SUBJECT: Responds to Item III-1, NRC question re design & const for systematic evaluation program seismic review. Response deals w/details of block walls throughout plant. Two oversized drawings encl.

Subject: Systematic Evaluation Program Seismic Review
R.E. Ginna Nuclear Power Plant
Docket No. 50-244

Response for NRC Question III-1

SECTION C
Scale 1/2" = 1'-0"

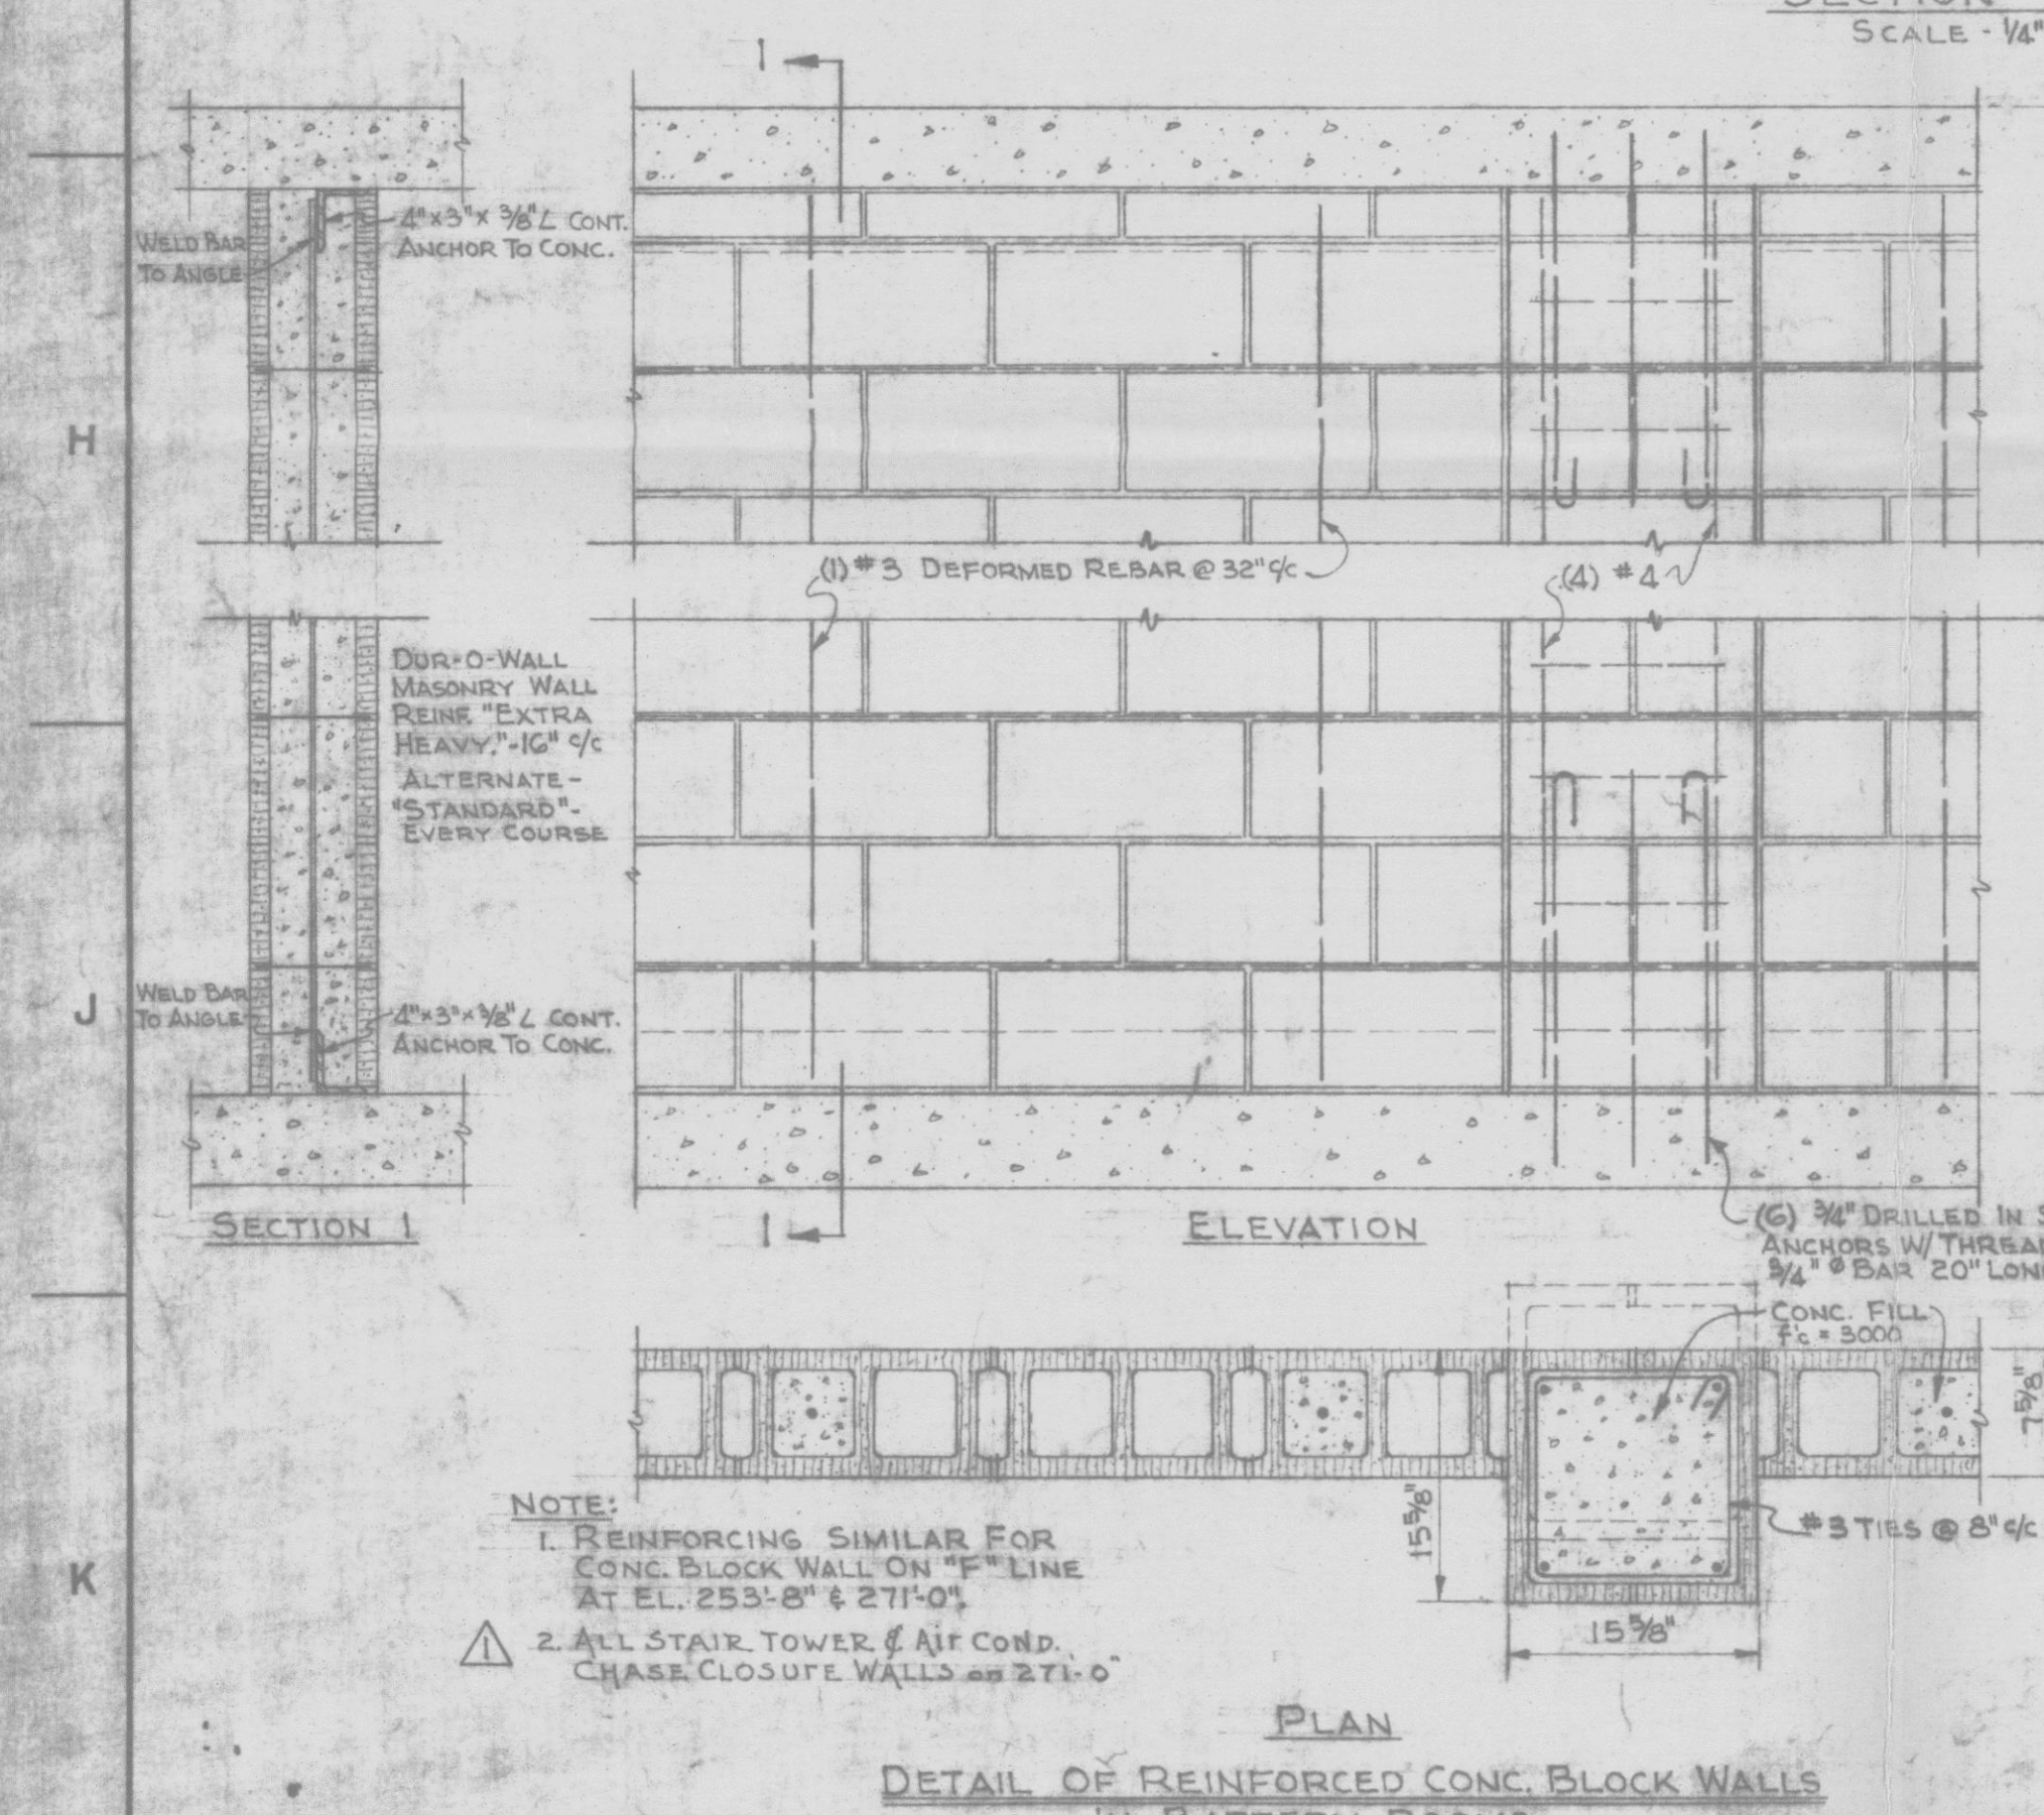
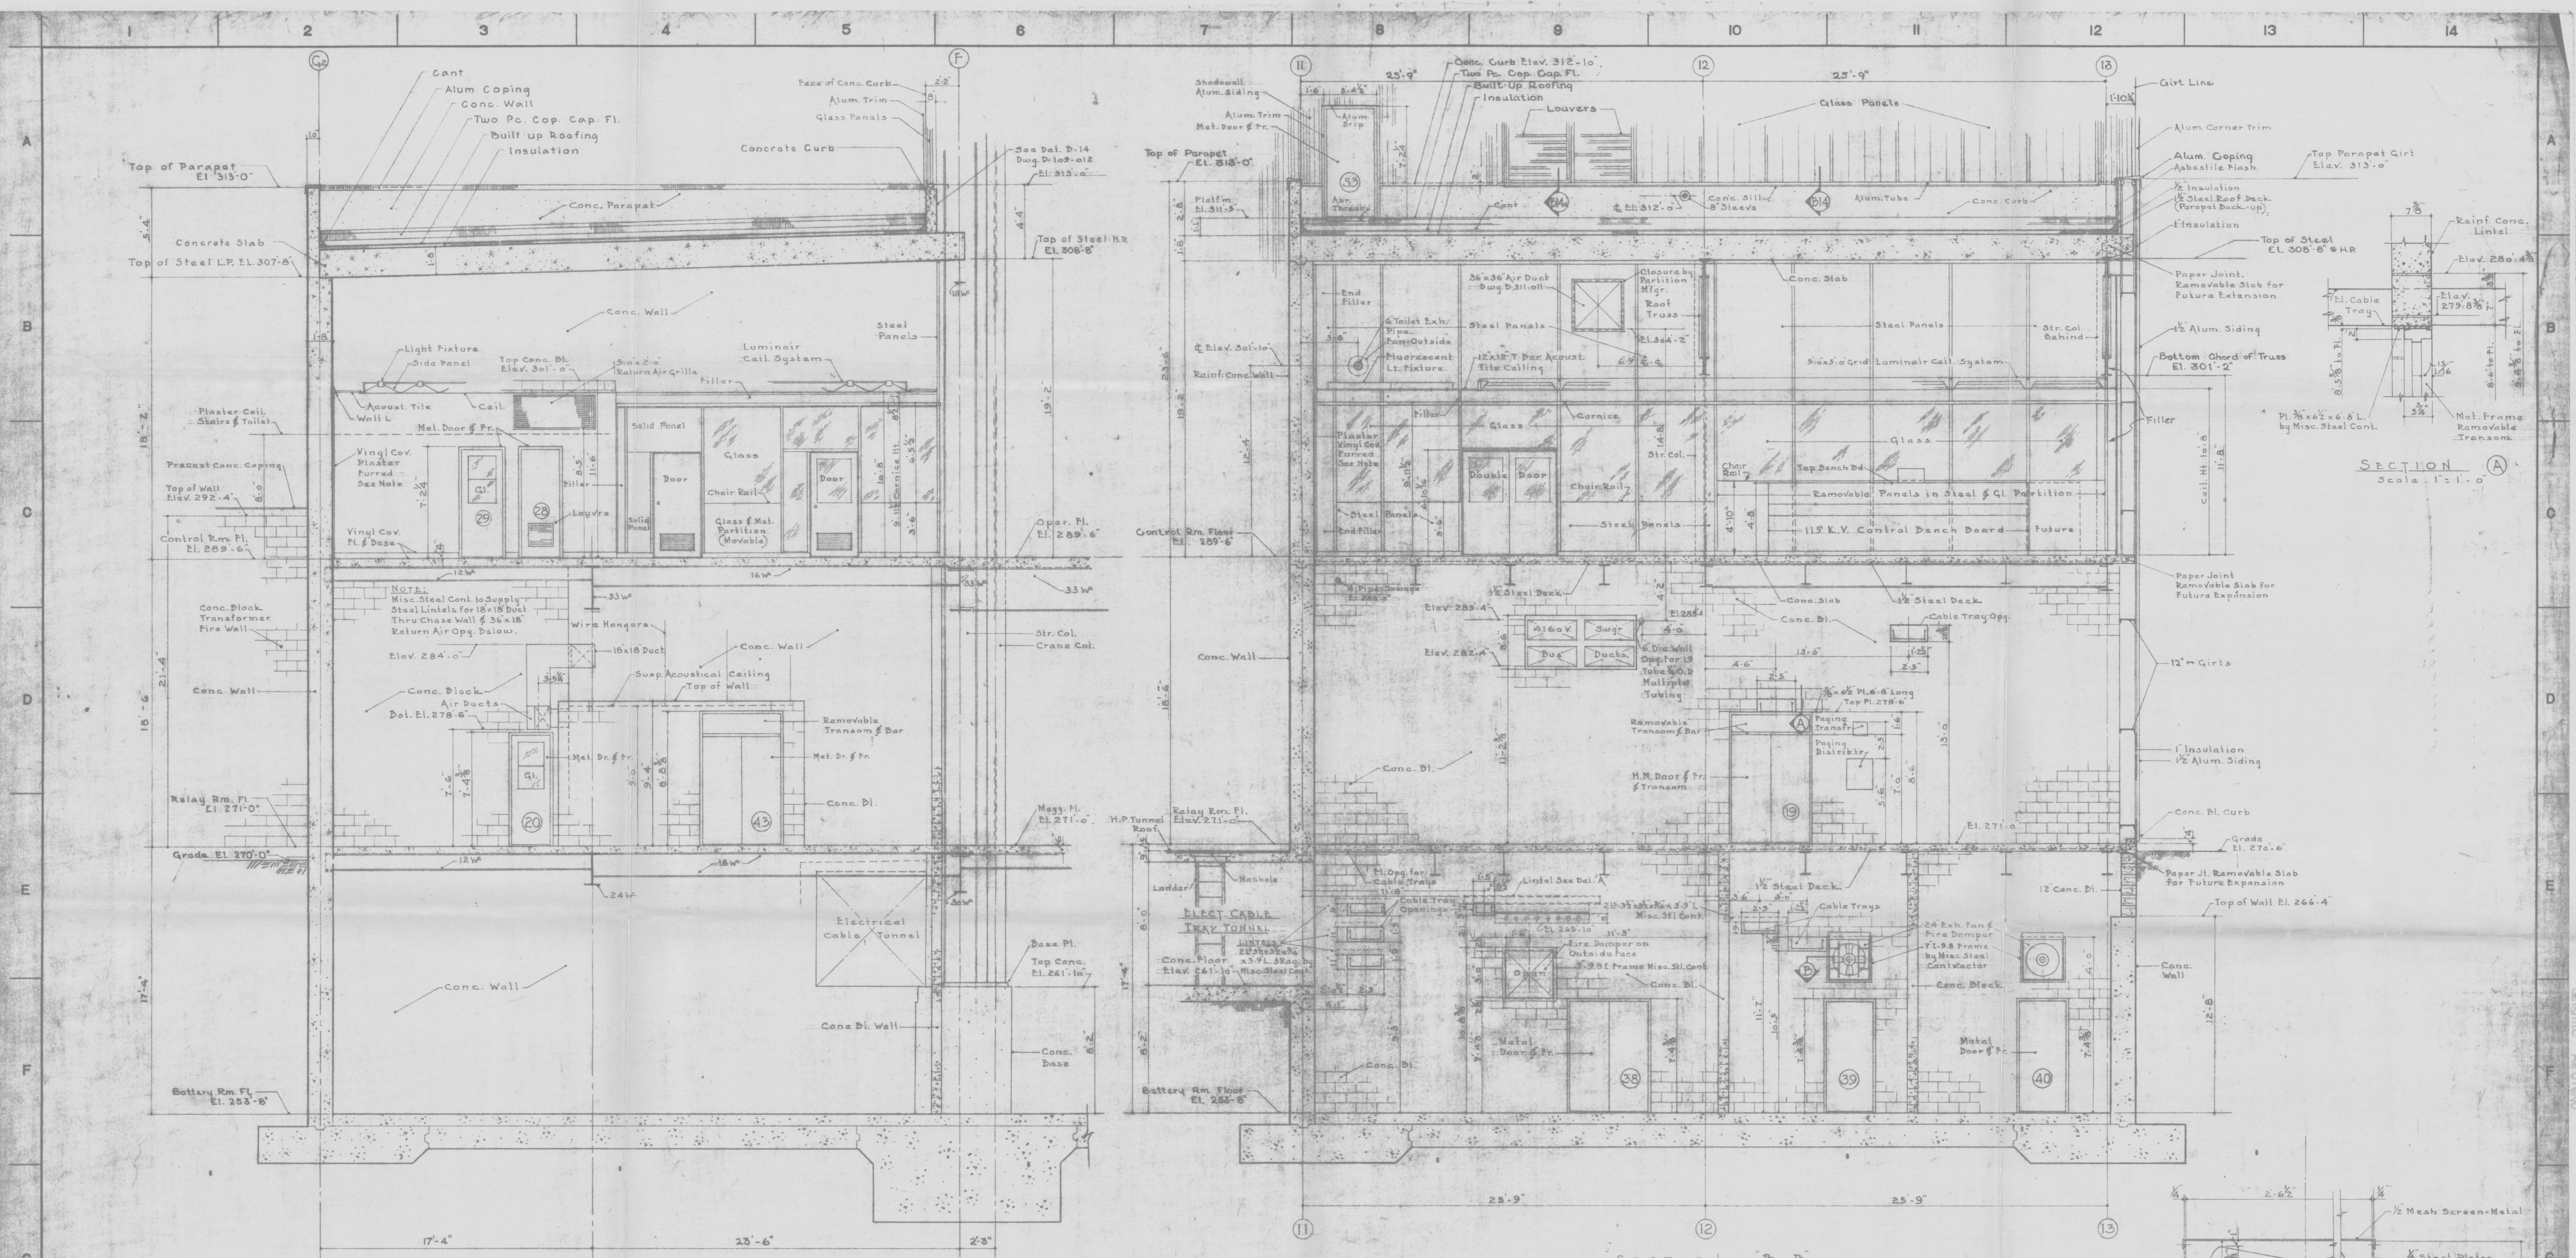
This letter supplements our earlier letters in responding to questions raised by the NRC Seismic Review Team on the design and construction of Ginna Station. Item III-1 identified in our letter of May 22, 1979 dealt with a request for information on details of the block walls throughout the plant. The attachment to this letter and the enclosed drawings respond to that request.

Reinforced concrete block walls are used in the Control Building and for the freight elevator shaft inside the Containment Building. Details of the reinforcement in the block walls are presented on drawings D-105-011 and D-105-012. Reinforcement details for the elevator shaft are the same as those presented for the Battery Room walls in the Control Building. All other block walls throughout the plant have reinforcement provided in the horizontal layers as follows:

1. Horizontal bed reinforcement is Dur-O-Wal standard truss design or Hohmann & Barnard, Inc. Trus-Mesh, of width two inches less than the nominal thickness of the wall. Bed reinforcing is laid in alternate courses, splice lapped six inches, cut and bent at corners. Over openings reinforcement is laid in the first and second bed joint and extends 24 inches on either side.
2. At junctions of partitions and walls, ties $1\frac{1}{2}$ " x $\frac{1}{4}$ " x 8" flats with two inch right angle bends at either end are inserted at 24 inch centers.
3. At steel columns, wall anchors 2" x $\frac{1}{4}$ " flats with two inch right angle bends at either end are provided at 24 inch centers. Ties are extended approximately to the center of the block wall.

Concrete masonry blocks are hollow units, conforming to ASTM C90-66T, Grade G-II and mortar conforming to ASTM C270-64T, Type N.
